JOSEPH M. FARLEY NUCLEAR PLANT-UNIT 2
ALABAMA POWER COMPANY
REPORT OF 10CFR50.55(e) DEFICIENCY

FIGURE 2 CORRECTIVE ACTION-TRAIN A

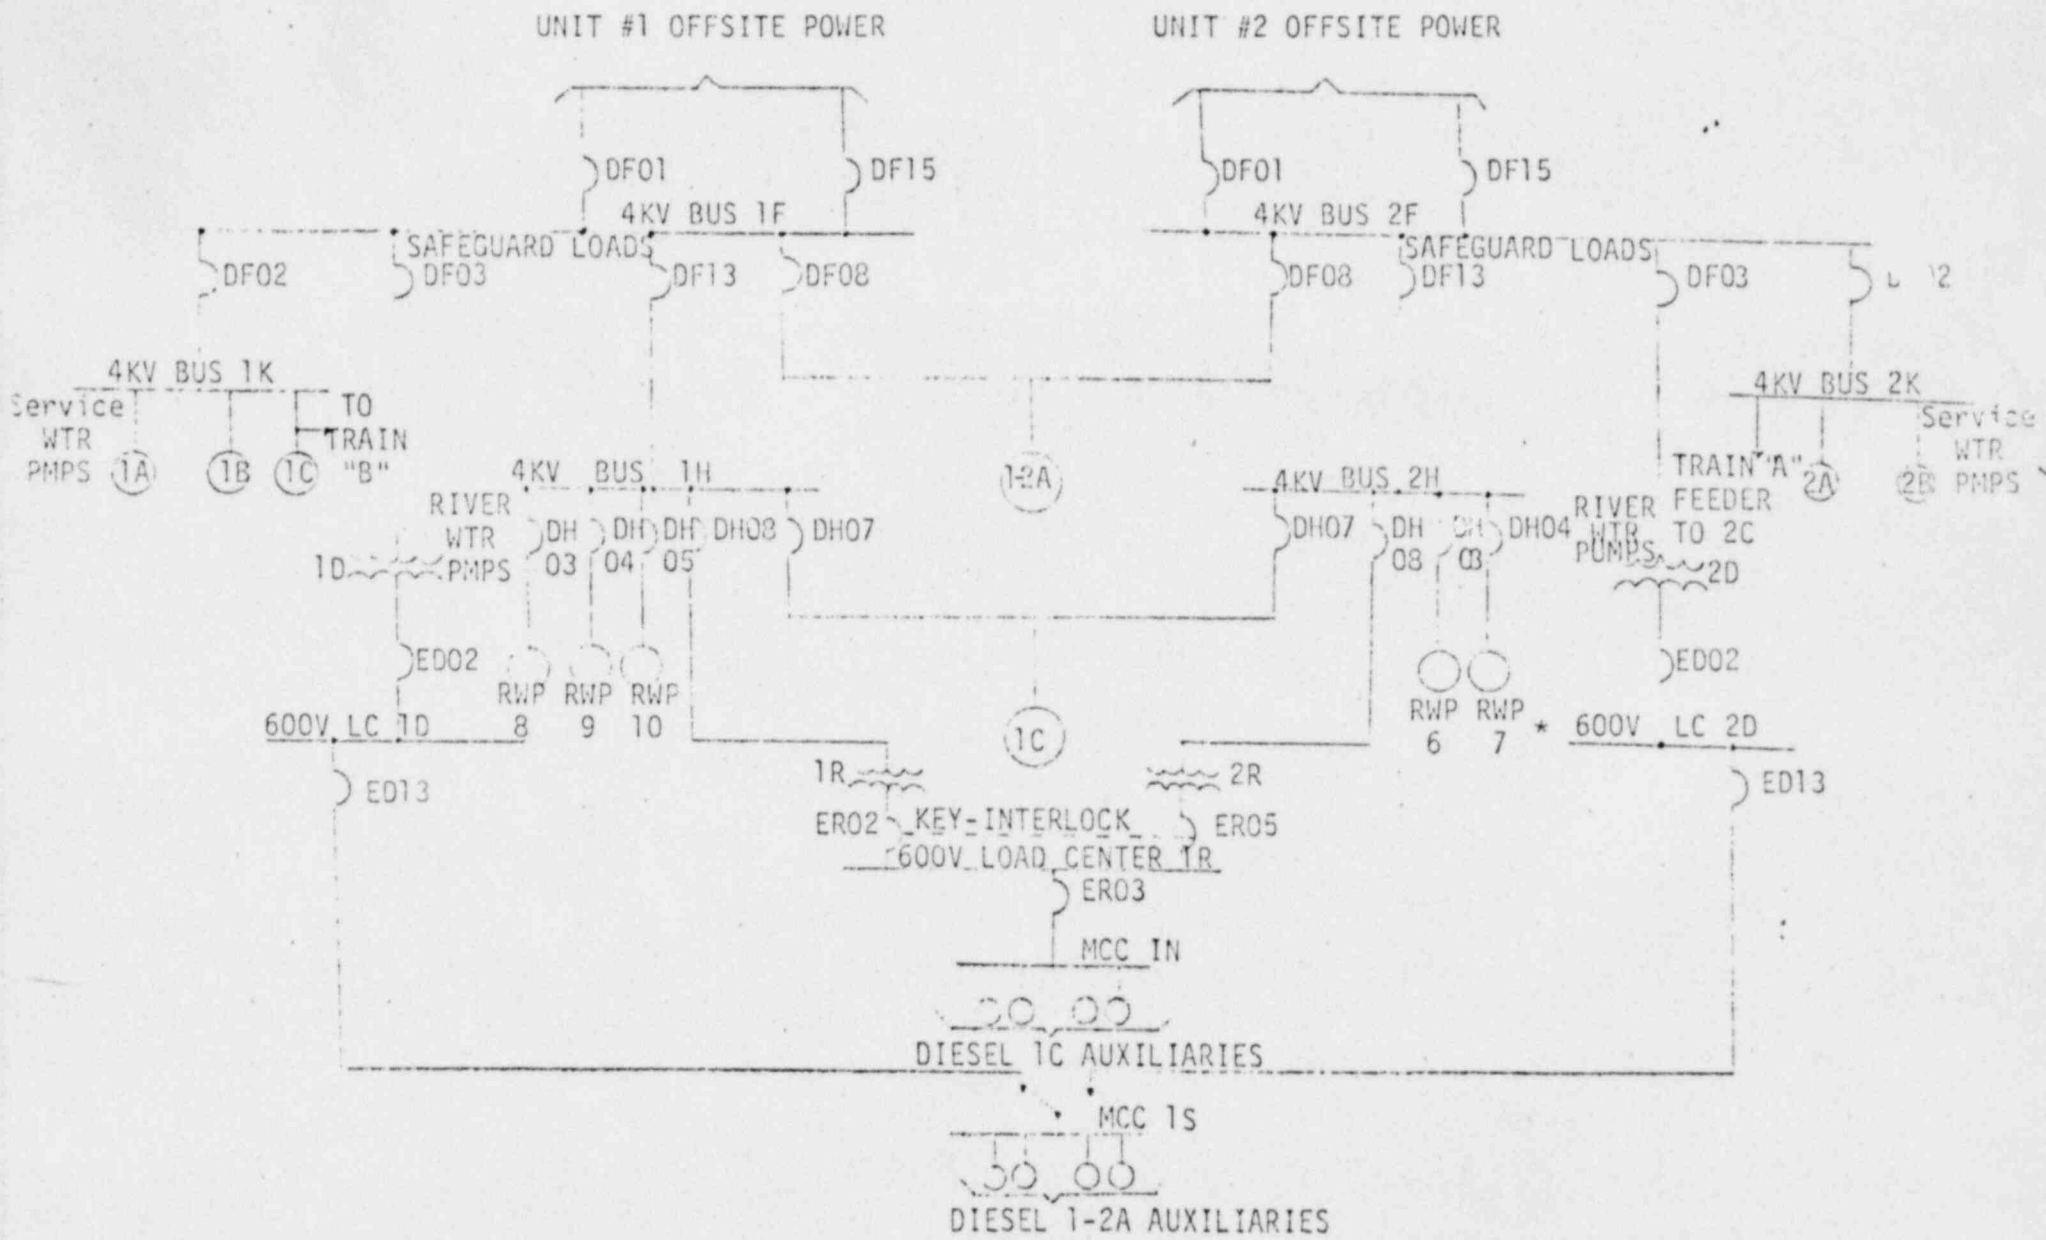
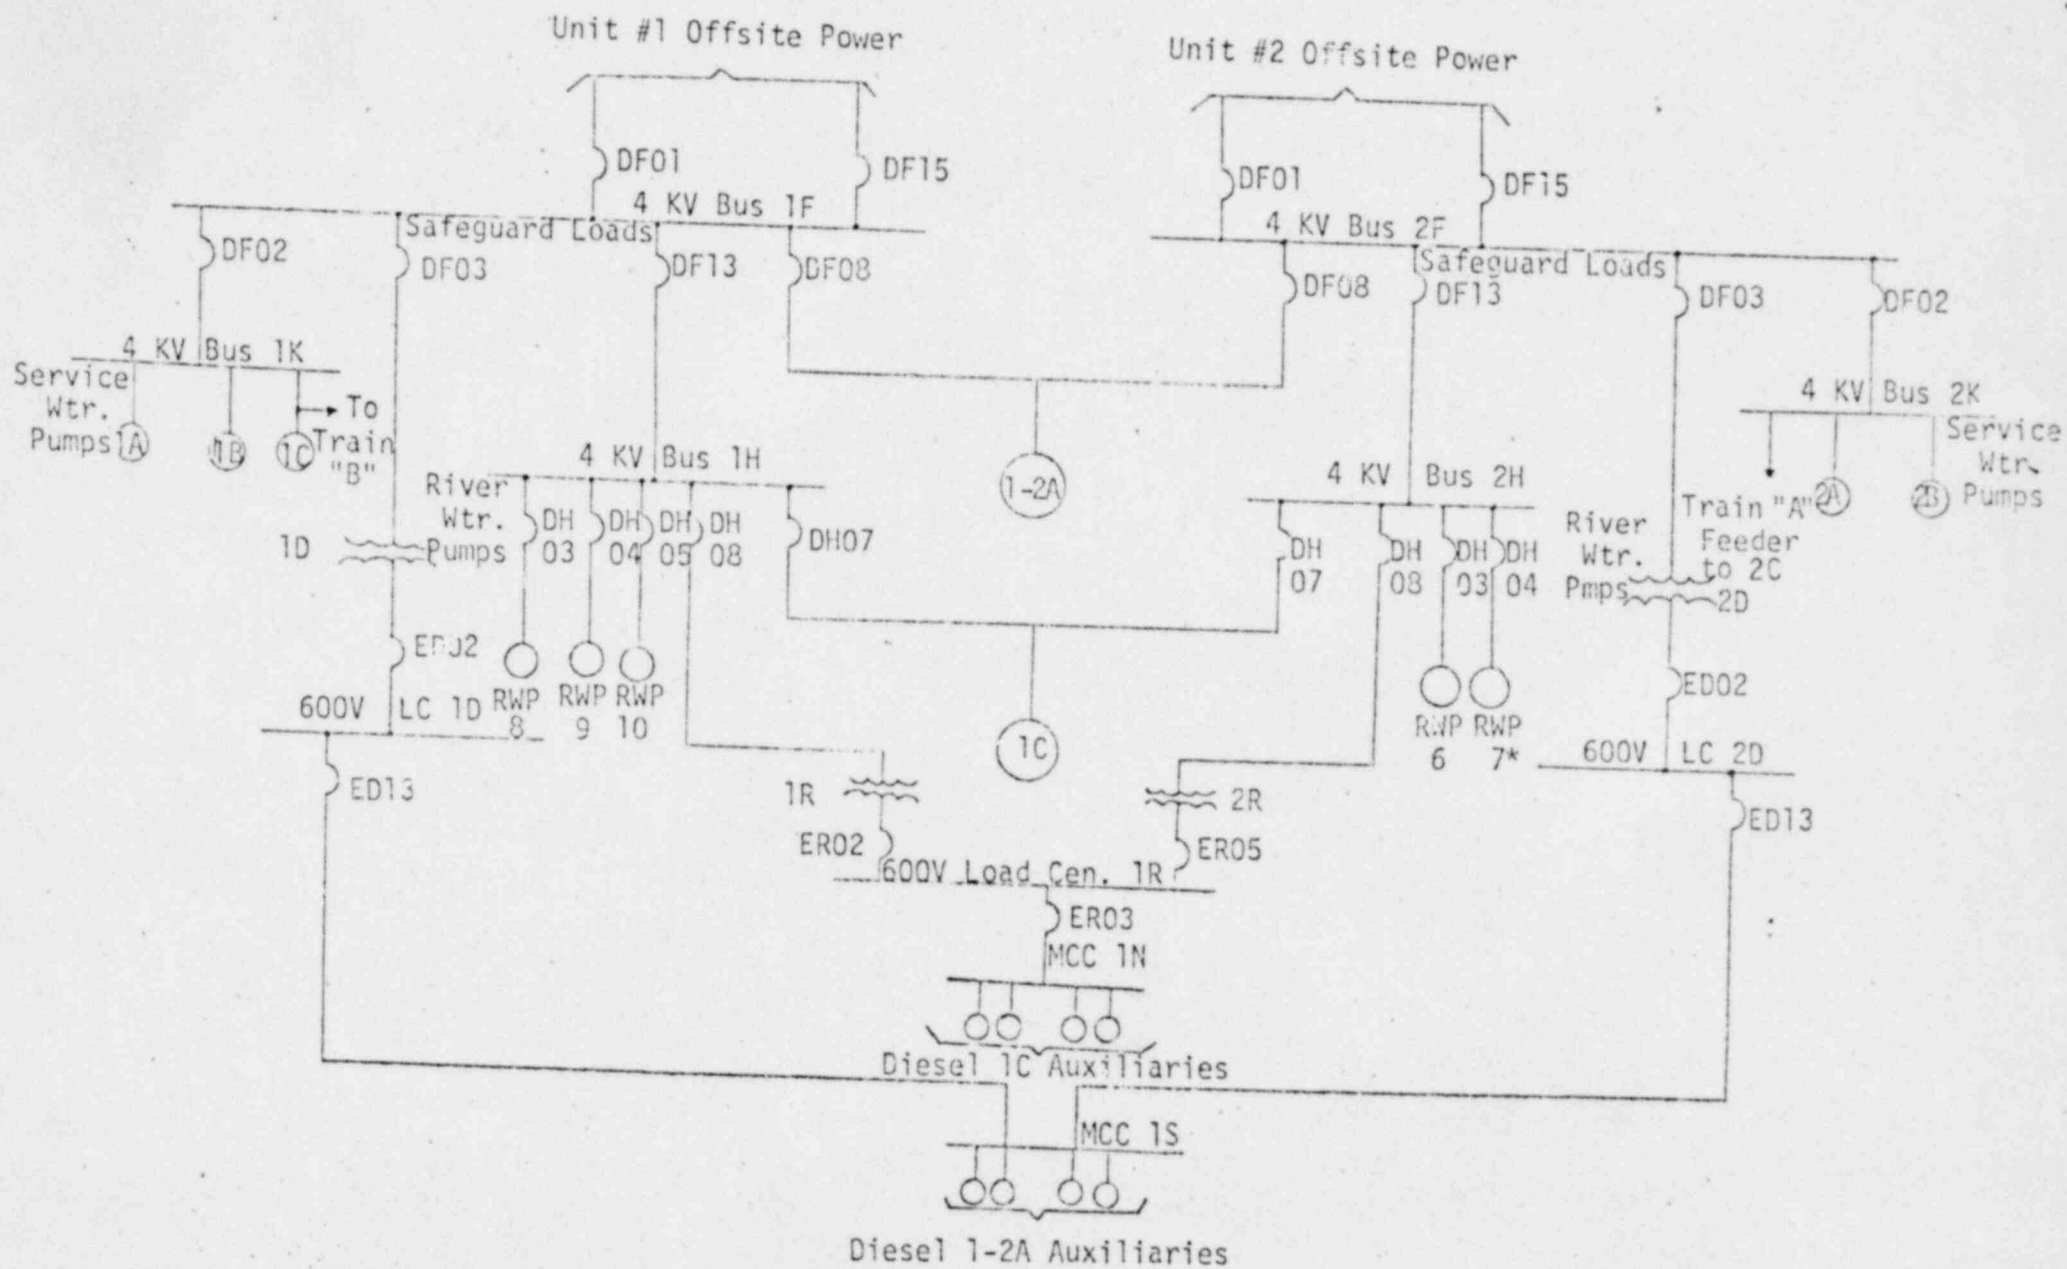
Presently, as shown in Figure 1, Diesel Generator 1C has its auxiliaries powered from emergency Motor Control Center (MCC) 1N. MCC 1N gets its power supply from emergency 600V Load Center 1R. The 600V Load Center 1R is a shared load center capable of being energized from either unit. When it is energized from Unit 1 it is supplied from the 4KV Bus 1H through Station Service Transformer 1R. When it is energized from Unit 2 it is supplied from the Unit 2 4 KV Bus 2H through Station Service Transformer 2R. The two 600V incoming breakers of 600V Load Center 1R are key interlocked so that only one can be closed at any time. The alignment of Load Center 1R to Unit 1 or Unit 2 can be performed manually only, from the local control panel located in the diesel building.

As shown in Figure 1, Diesel Generator 1-2A has its auxiliaries powered from emergency MCC 1S. MCC 1S is a shared MCC capable of being energized from either unit. When it is energized from Unit 1 it is supplied from the Unit 1 600V Load Center 1D, which in turn is powered from Unit 1 4KV Bus 1F through Station Service Transformer 1D. When it is energized from Unit 2 it is supplied from the Unit 2 600V Load Center 2D, which in turn is powered from Unit 2 4 KV Bus 2F through Station Service Transformer 2D. The alignment of MCC 1S to Unit 1 or Unit 2 can be performed manually only from the MCC 1S located in the diesel building.

Under LOSP on both units or LOSP on both units and LOCA on Unit 1, Diesel 1C is a source of power for Unit 2 Train A hot shutdown loads, while Diesel 1-2A is a source of power for Unit 1 LOCA loads. If, at the accident occurrence, 600V Load Center 1R is aligned to Unit 1, it will be deenergized since 4 KV Bus 1H is deenergized, and Diesel Generator 1C loses its auxiliaries. At this time, MCC 1N

has to be connected to Station Service Transformer 2R by the manual operation of the key interlocked incoming breakers of 600V Load Center 1R. Diesel generator manufacturer has specified that diesel generator can run without its auxiliaries for one minute if the engine is at operating temperature, or for three minutes from cold start. If the manual changeover of power source to MCC 1R cannot be accomplished in the specified time, Diesel Generator 1C could be automatically tripped because of low lube oil pressure, or damaged because of loss of cooling water. The high cooling water temperature is alarmed, but does not trip the diesel generator automatically under accident conditions.

If Diesel Generator 1C is disabled, no source of power for Unit 2 Train A safeguard loads will be available, and a single failure on Unit 2 Train B can render Unit 2 incapable of being shutdown. (4 KV Bus 1H is deenergized under the postulated conditions since the tie breaker between 4 KV Bus 1F and 4 KV Bus 1H is open.)

If, under the above conditions MCC 1S is aligned to Unit 2, it will be deenergized and Diesel Generator 1-2A loses its auxiliaries. If Diesel Generator 1-2A is disabled, no source of power for Unit 1 Train A LOCA loads will be available. In this case, if we apply the single failure criterion to Unit 1 Train B instead of Unit 2 Train B, Unit 2 will meet the hot shutdown requirements, while Unit 1 cannot meet the LOCA requirements.

Under LOSP on both units and LOCA on Unit 2, Diesel Generator 1C is the source of power for Unit 1 Train A hot shutdown loads, while Diesel Generator 1-2A is the source of power for Unit 2 LOCA loads. If, at the accident occurrence 600V Load Center 1R is aligned to Unit 2, it will be deenergized since 4 KV Bus 2H is deenergized, and Diesel Generator 1C loses its auxiliaries. Diesel Generator 1C will be disabled, no source of power for Unit 1 Train A safeguard loads will be available, and a single failure on Unit 1 Train B can render Unit 1 incapable of being shutdown. (4 KV Bus 2H is deenergized under the postulated conditions since the tie breaker between 4KV Bus 2F and 4 KV Bus 2H is open.)

If, under the above conditions MCC 1S is aligned to Unit 1, it will be deenergized, Diesel Generator 1-2A disabled, and no source of power for Unit 2 Train A LOCA loads will be available. In this case, if we apply the single failure criterion to Unit 2 Train B instead of Unit 1 Train B, Unit 1 will meet the hot shutdown requirements, while Unit 2 cannot meet the LOCA requirements.

To correct the first problem the following corrective action will be taken (refer to Figure 2):

(1) The key interlock feature of breakers ER02 and ER05 on Load Center 1R will be removed and replaced by an electrical interlock, so that only one of the two breakers could be closed at any time.

The electrical circuitry of these breakers will be changed to accomplish the following: (a) automatically connect Load Center 1R to Bus 1H (ER02 closed and ER05 open) when Diesel Generator 1C is aligned to Unit 1 (DH07 on Bus 1H closed); (b) automatically connect Load Center 1R to Bus 2H (ER05 closed and ER02 open) when Diesel Generator 1C is aligned to Unit 2 (DH07 on Bus 2H closed).

(2) Manual transfer switch on MCC 1S will be removed and the incoming feeders from Load Centers 1D and 2D will be solidly connected to the MCC.

Breakers ED13 on Load Center 1D and ED13 on Load Center 2D will be electrically interlocked, so that only one of the two breakers could be closed at any time. The electrical circuitry of these breakers will be changed to accomplish the following: (a) automatically connect MCC 1S to Load Center 1D (ED13 on Load Center 1D closed and ED13 on Load Center 2D open) when Diesel Generator 1-2A is aligned to Unit 1 (DF08 on Bus 1F closed); (b) automatically connect MCC 1S to Load Center 2D (ED13 on Load Center 2D closed and ED13 on Load Center 1D open) when Diesel Generator 1-2A is aligned to Unit 2 (DF08 on Bus 2F closed).

FIGURE 3 PRESENT CONFIGURATION -TRAIN B
 (The corrective action necessitates no change to this figure.) * Manually Loaded

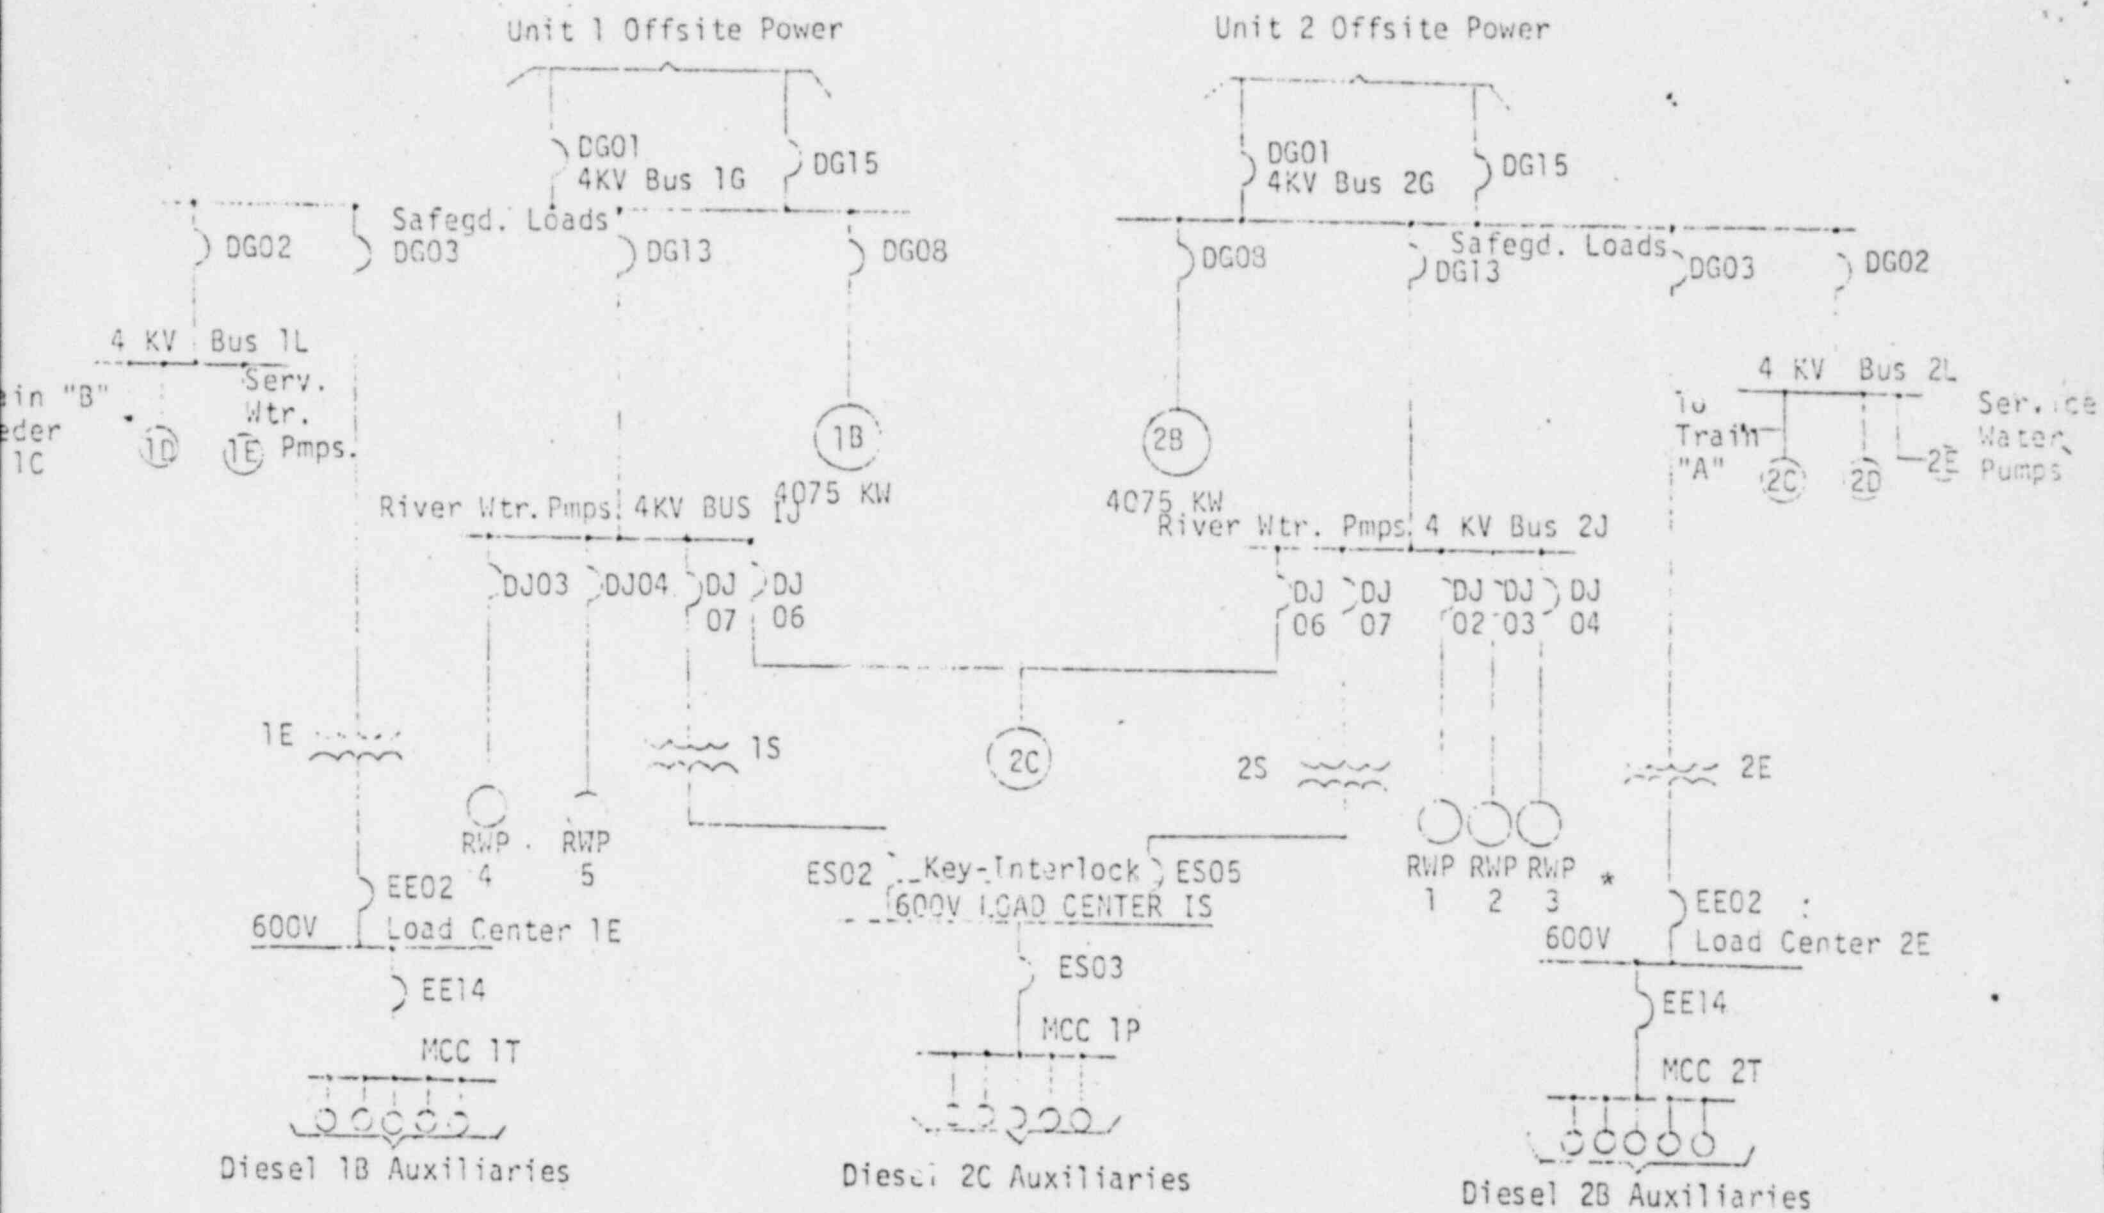
A second problem identified concerning the diesel generator relates to the following. The Farley Nuclear Plant is intended to be designed to accommodate the Loss of Pond Dam along with Loss-of-Offsite Power and a single failure. Under this event, the river water systems will be automatically diverted to the wet pit which supplies suction to service water pumps.

For this event, for Unit 1 operation alone, a minimum of 2 river water pumps will be required. Therefore, to accommodate single failure, 4 river water pumps are powered from the diesel generator system.

For Unit 1 and Unit 2 operation, a minimum of 4 river water pumps are required and to accommodate single failure, 8 river water pumps are to be sequenced onto the diesel generator system.

With Unit 1 in operation alone two (2) emergency power sources (diesel generator 1C-Train A and diesel generator 2C-Train B) are dedicated to the River Water System. Four river water pumps with automatic starting capability are available so that in the event of single failure at least 2 river water pumps will start, meeting the minimum requirements for safe shutdown of the unit. Therefore, there is no deficiency for Unit 1 operation.

However, after two units go into operation, only one emergency power source (diesel generator 2C-Train B) is dedicated to the River Water System, hence only

4 river water pumps with automatic capability would be available. The failure of diesel generator 2C could leave the entire plant with no river water pumps available. This deviates from our commitment in the FSAR and does not meet the minimum River Water System availability requirements for safe shutdown of both Units. Redesign to provide a minimum of four river water pumps on Loss of Offsite Power is underway.

In order to correct the second problem, the following changes to the logic, schematic, and wiring concerning the diesel generator are proposed (see Figures 1, 2 and 3):

(1) After the sequencer has added the LOSP loads to Bus 1F, the 4 KV Bus 1F will furnish power to the 4 KV Bus 1H. Three Unit 1 Train A river water pumps (Numbers 8, 9, and 10) will be started on Bus 1H in sequence.

(2) The LOSP sequencer on Bus 2F will be modified to eliminate containment cooler 2B from being added automatically. As in the past, containment cooler 2A will be automatically applied to Bus 2F. After LOSP sequencer has added LOSP loads to Bus 2F, the river water pumps sequencer on Bus 2H will be unblocked to enable one river water pump (Number 6) to automatically be applied to Bus 2H.

(3) Should diesel generator 2C fail, diesel generator 1B will furnish power to Bus 1J and diesel generator 2B will furnish power to Bus 2J after the sequencers on Buses 1G and 2G have had LOSP loads added. Two river water pumps (Numbers 4 and 5) will start on Bus 1J and two river water pumps (Numbers 1 and 2) will start on Bus 2J.

(4) The existing feature of the diesel generator 2C working like a backup for diesel generator 1B or 2B if either fails to furnish power to the hot shutdown load will be removed. This feature is not required to meet single failure criteria.
